KLUGE PLACE SUBDIVISION

APPLICATION NUMBER 5 DATE October 2, 2014

APPLICANT Kluge Place Subdivision

REQUEST Subdivision

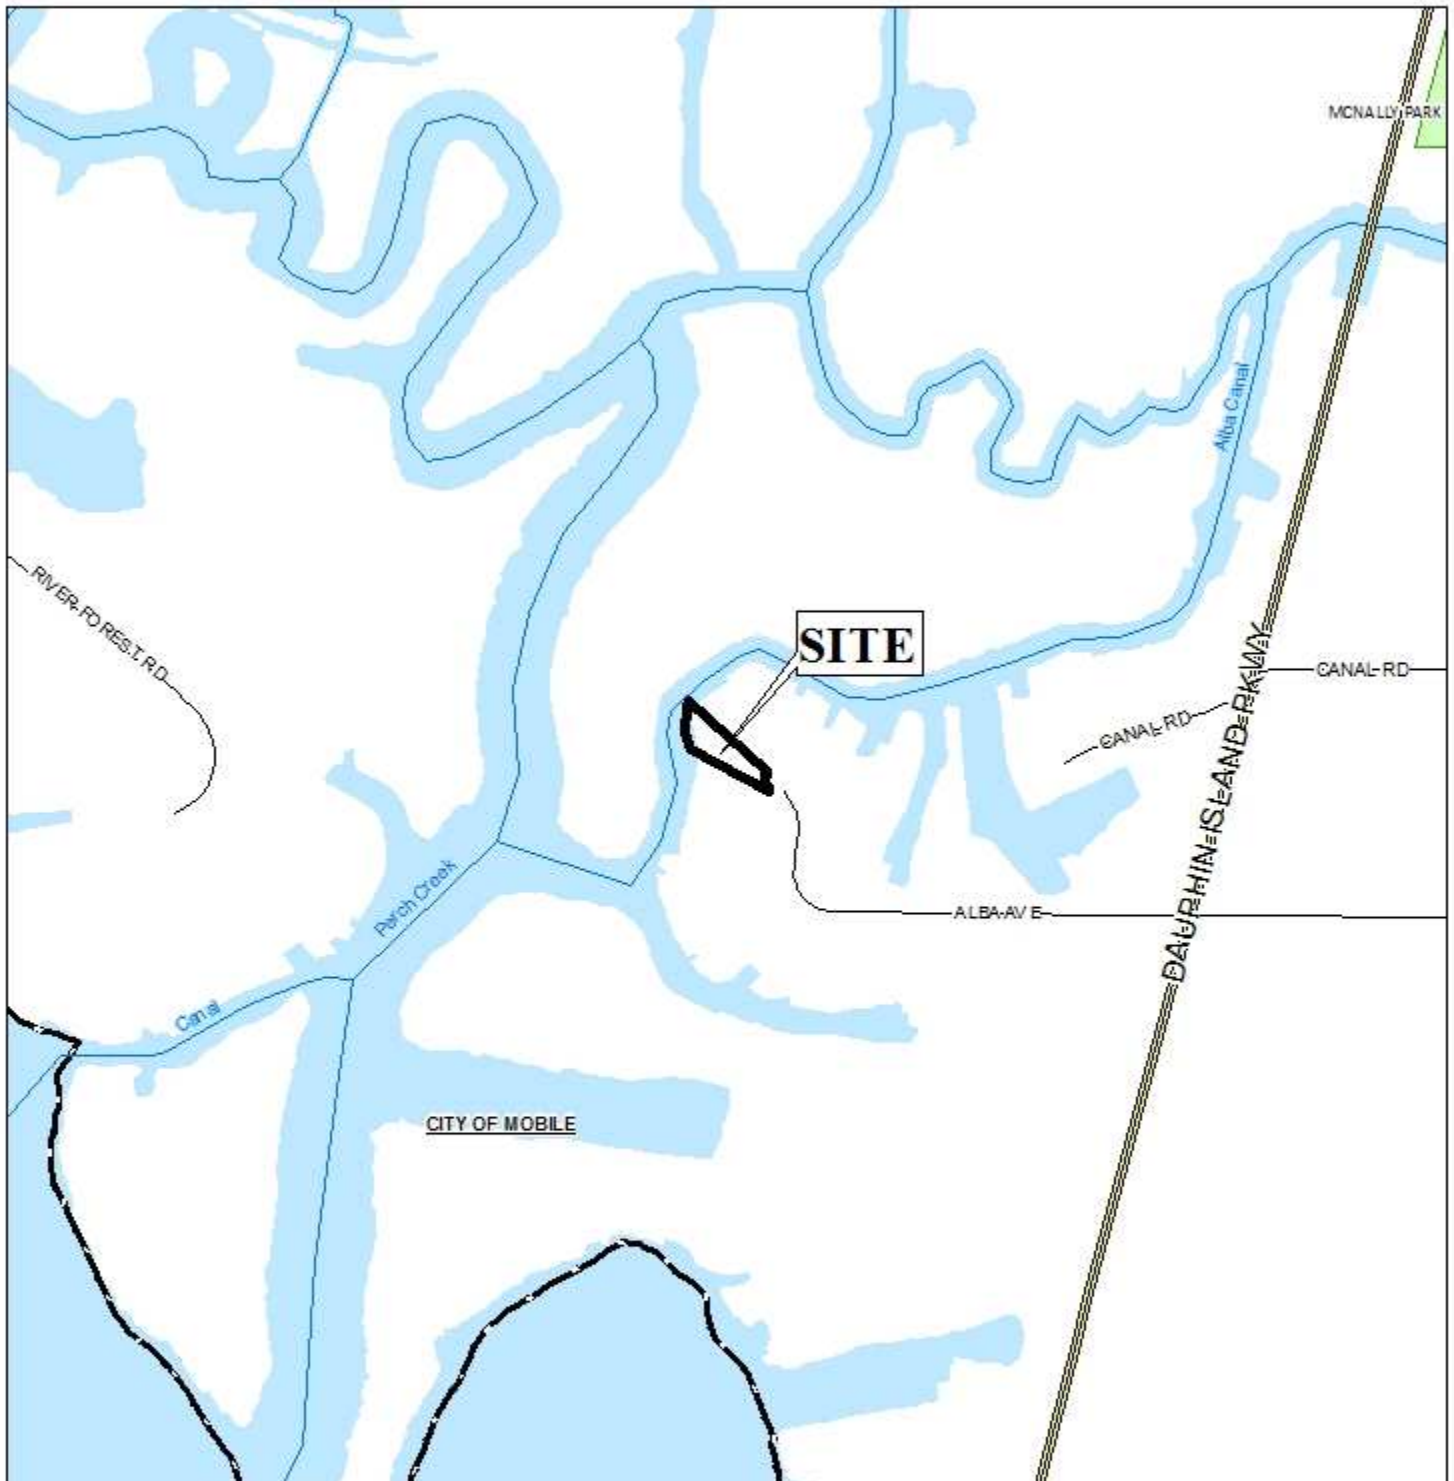
The site fronts Alba Avenue, a minor street with a required 60' right-of-way. This portion of Alba Avenue is located within a cul-de-sac with a median, and typically dedication to provide right-of-way for the cul-de-sac would be required. However, the Planning Commission waived this requirement for the adjacent property (2 lots over) in 2005; thus, no dedication should be required for this application in order to maintain consistency. Furthermore, the preliminary plat illustrates the right-of-way width as variable; this should be revised to depict the minimum right-of-way width adjacent to the property.

The 25-foot minimum building setback line, required in Section V.D.9., is noted on the plat but not illustrated. Revisions should be made to depict the 25' minimum building setback line on the Final Plat.

The plat depicts the lot size in square feet and acres and, this should be retained on the Final Plat, or a table should be furnished providing the same information, if approved.

- 1) labeling of the right-of-way width of Alba Avenue to coincide with the right-of-way width adjacent to the property;
- 2) revision of the plat to depict the 25-foot minimum building setback line as required by Section V.D.9. of the Subdivision Regulations;

- 3) retention of the lot size in acres and in square feet or the furnishing of a table on the Final Plat providing the same information;
- 4) placement of a note on the Final Plat stating that the lot is limited to the existing curb-cut, with any changes to the size, design, and location to be approved by Traffic Engineering, and conform to AASHTO standards;
